Remedies for comments #105, #106, #107
IEEE802.3bt Draft 2.1 Annex 33C

rev.: 1.2

Miklos Lukacs (Silicon Labs) | 12 Nov 2016

Connection Check sequence diagrams

Figure 33C-2—PSE implementing CC_DET_SEQ=0, do_cxn_chk result is dual, simultaneous power on

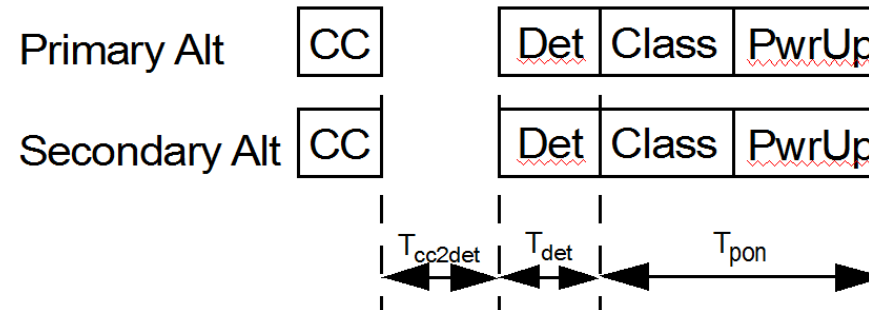
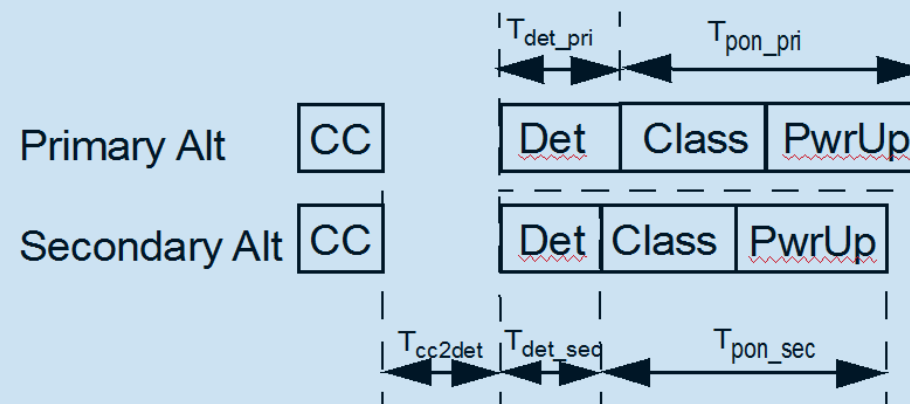
CC_DET_SEQ=0 when the result of connection check is dual and Class_4PID_mult_events_sec is TRUE

comments #106,107

Proposed new Figure 33C-2

Figure 33C-2—PSE implementing CC_DET_SEQ=0, do_cxn_chk result is dual; quasi-simultaneous power on

Figure 33C-5—PSE implementing CC_DET_SEQ=1, do_cxn_chk result is dual, simultaneous power on

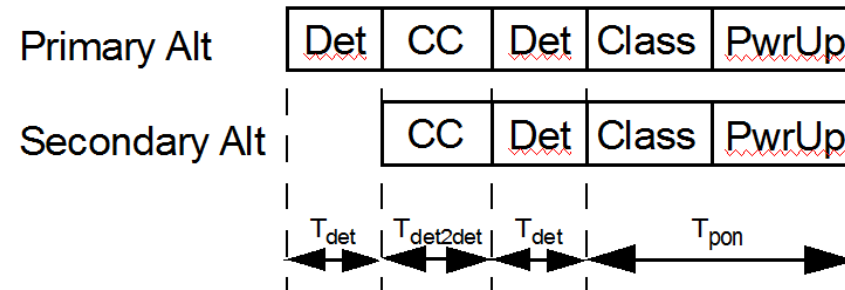
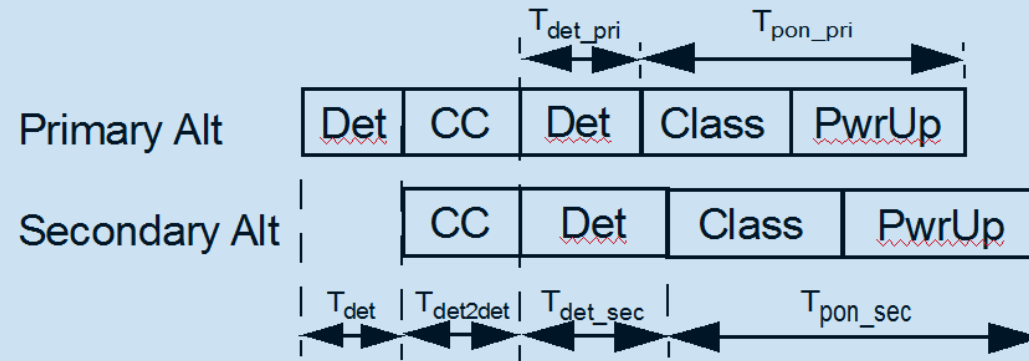
CC_DET_SEQ=1 when the result of connection check is dual and Class_4PID_mult_events_sec is TRUE

comments #106,107

Proposed new Figure 33C-5

Figure 33C-5—PSE implementing CC_DET_SEQ=1, do_cxn_chk result is dual, quasi-simultaneous power on

Figure 33C-8—PSE implementing CC_DET_SEQ=2, do_cxn_chk result is dual, simultaneous power on

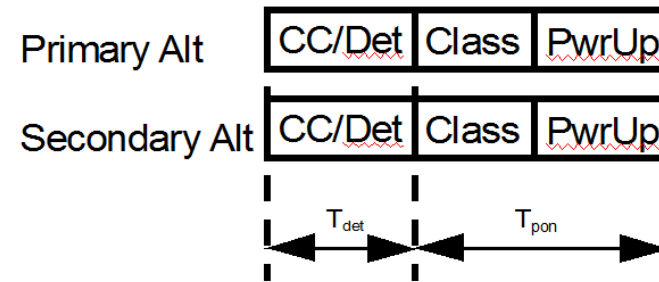
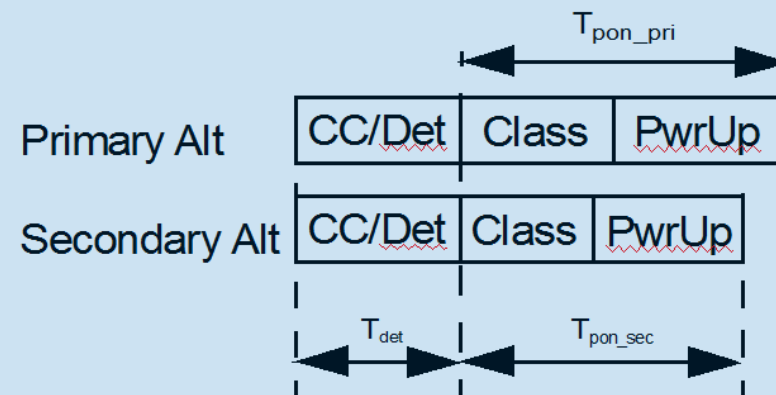
CC_DET_SEQ=1 when the result of connection check is dual and Class_4PID_mult_events_sec is TRUE

comments #106,107

Proposed new Figure 33C-8

Figure 33C-8—PSE implementing CC_DET_SEQ=2, do_cxn_chk result is dual, quasi-simultaneous classification and power on

Figure 33C-13—PSE Single-Event Physical Layer classification

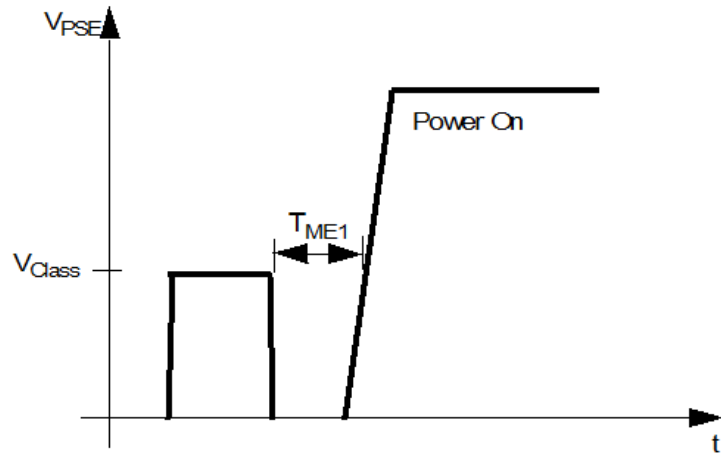
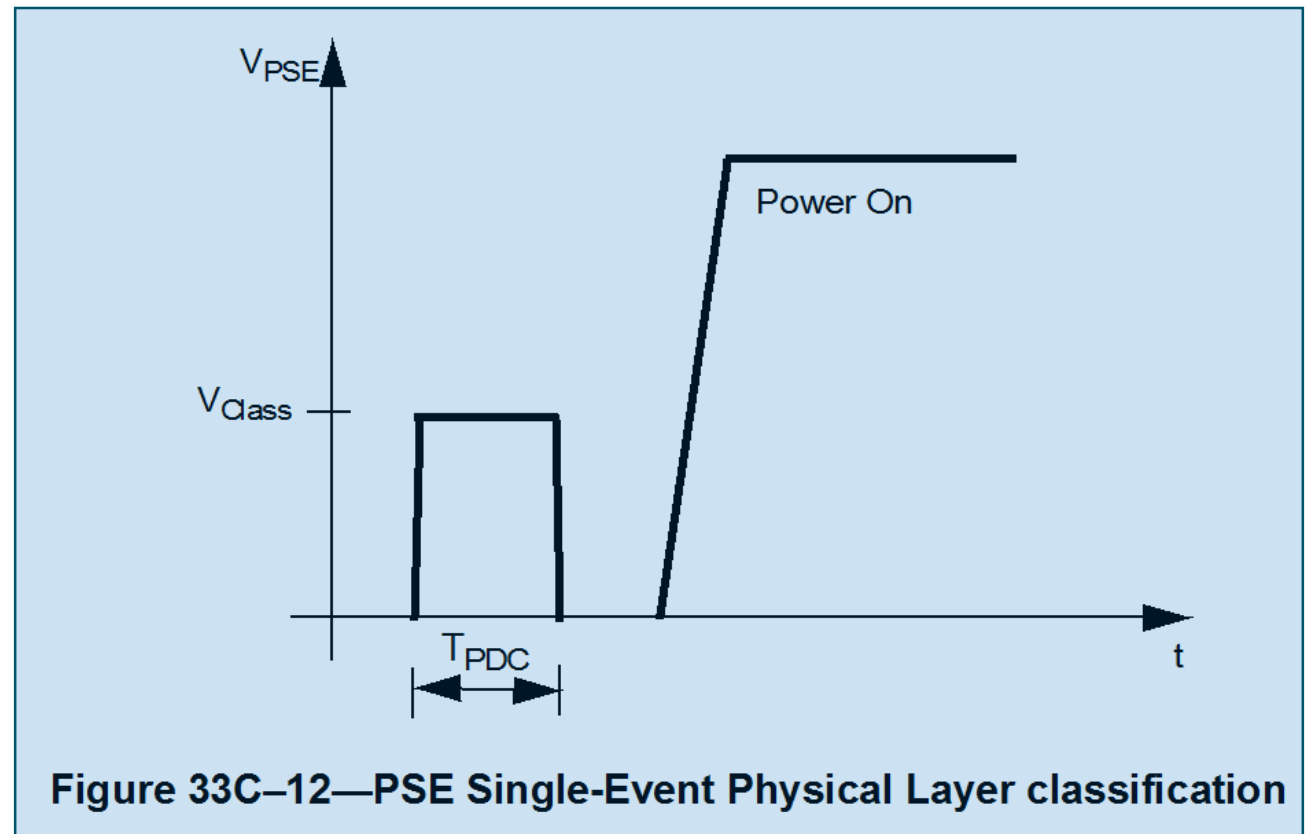
Single-Event classification

comment #105

Proposed new Figure 33C-13

Figure 33C-12—PSE Single-Event Physical Layer classification
